# UNITED STATES PATENT AND TRADEMARK OFFICE

APPLICATION NO.	FILING DATE	FIRST NAMED INVENTOR	ATTORNEY DOCKET NO.	CONFIRMATION NO.
10/010,892	11/05/2001	Bradley W. Plattner	GRD0128.US	3059

# Office Action Summary

## DETAILED ACTION

FIG. 1

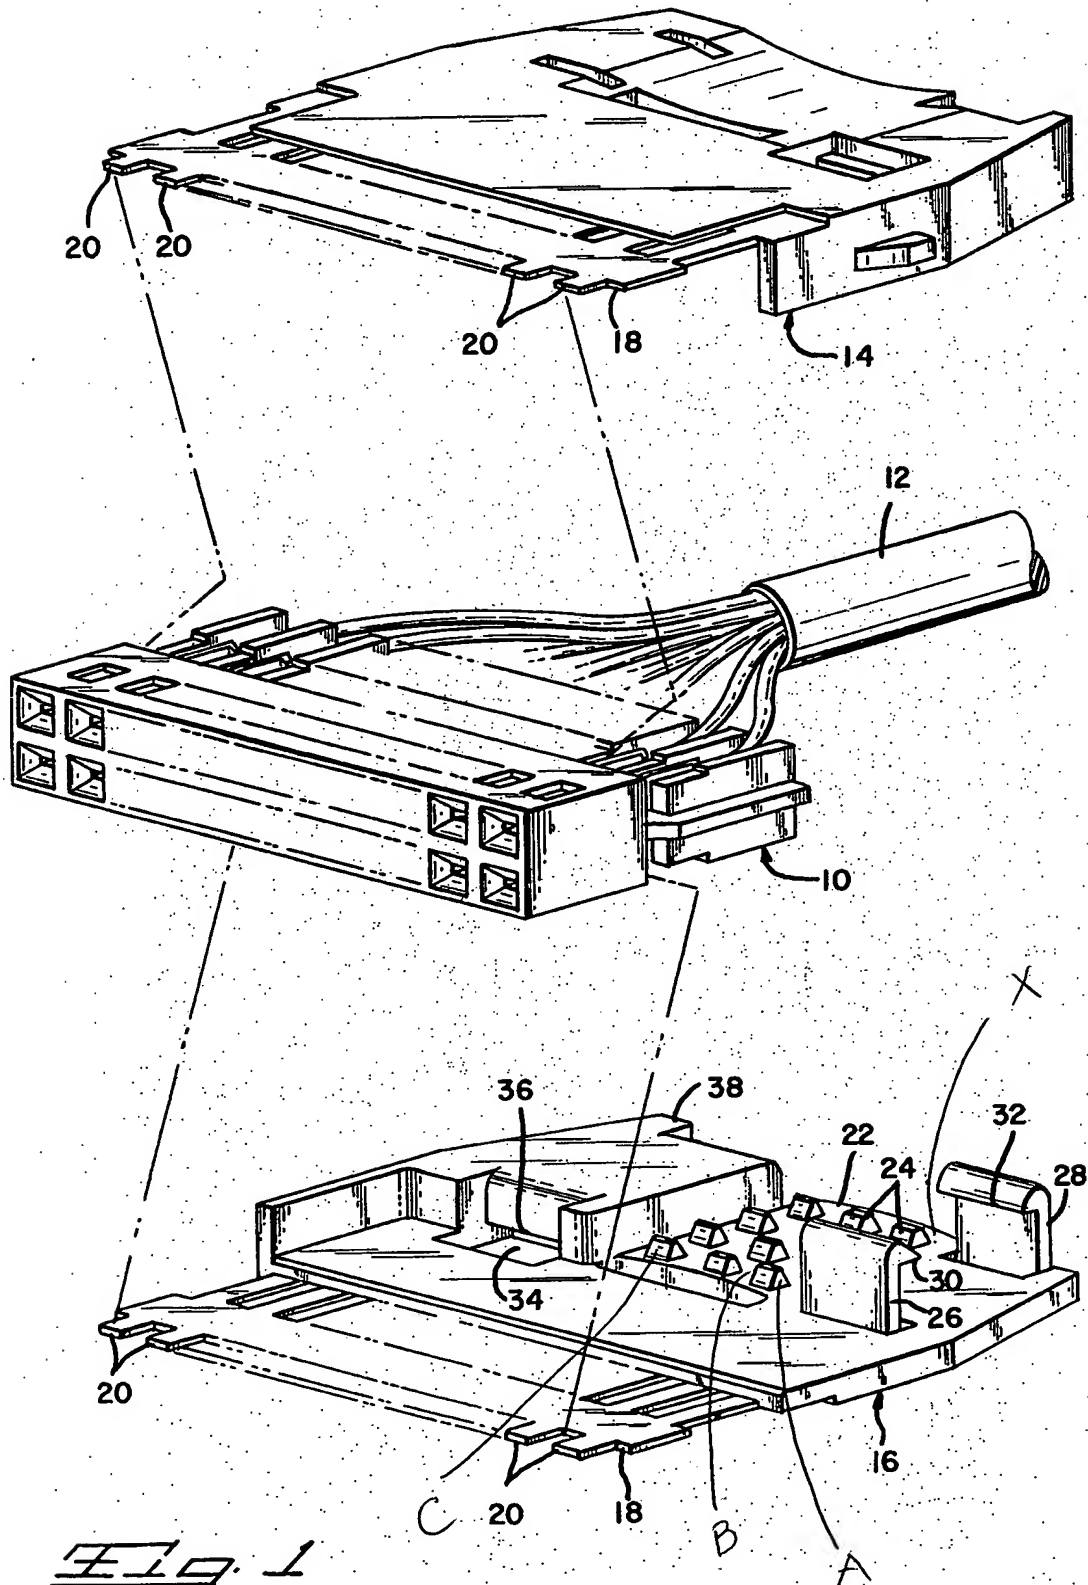
- a plurality of electrical conductors (46);
- a sleeve (12, a sheath for a cable) carries the plurality of electrical conductors (column 1, lines 31-33); and
- a connector (10 and 14, 16, a connector and a cover members, respectively) comprises a housing which including a first end has an opening with an inner surface (X, attachment) to accommodate the sleeve and the plurality of electrical conductors. The inner surface has a plurality of pointed projections (24, a plurality of teeth), each of the pointed projections has a ramped side (A, attachment), which is extending farther from the inner surface in a direction away from the opening.

✓ Regarding claims 3 and 10, Douty et al., figure 1, disclose an adjacent side (C, attachment) of the pointed projections forms an obtuse angle with the inner surface.

✓ Regarding claims 4 and 11, Douty et al., figure 1, disclose each of the pointed projections has a front side (B, attachment) which opposing with the ramped side and adjacent to two adjacent sides (C, attachment). The front side being generally perpendicular to the inner surface.

✓ Regarding claims 5-6 and 12-13, Douty et al., figure 1, disclose the plurality of pointed projections are formed a plurality of rows on the inner surface.

Douty et al., figure 1, disclose the pointed projections include two adjacent sides (C, attachment) being adjacent to the ramped side that is extending from the inner surface.
